RISO, INC. **PARTS CHANGE INFORMATION**

PART: SEPERATE SHEET; A4 **ISSUE #: 045**

NEW PART NUMBER: 017-12219 NEW DESCRIPTION: SEPERATE SHEET; A4 OLD PART NUMBER: 017-12219 OLD DESCRIPTION: SEPERATE SHEET; A4	[X] New [ ] Modified [ ] Obsolete [ ] Other
Compatible: [X] Not Compatible: [ ] Old/Obsolete: [Y]

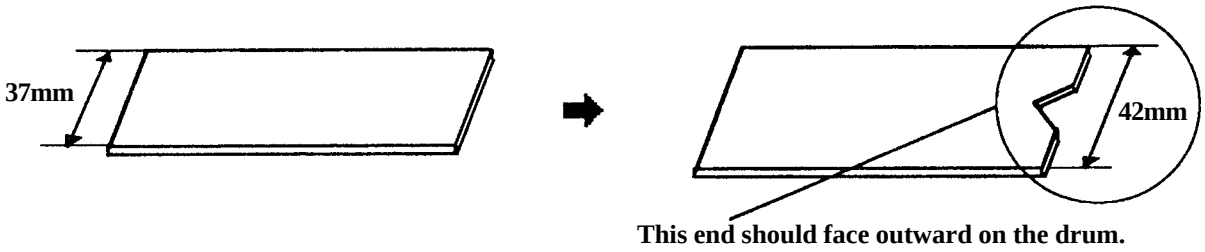
The width of the SEPERATION SHEET has been changed from 37mm to 42mm.
A V slot has been cut into the outward ends of the sheets.
This change was made to improve the seperation capabilities.
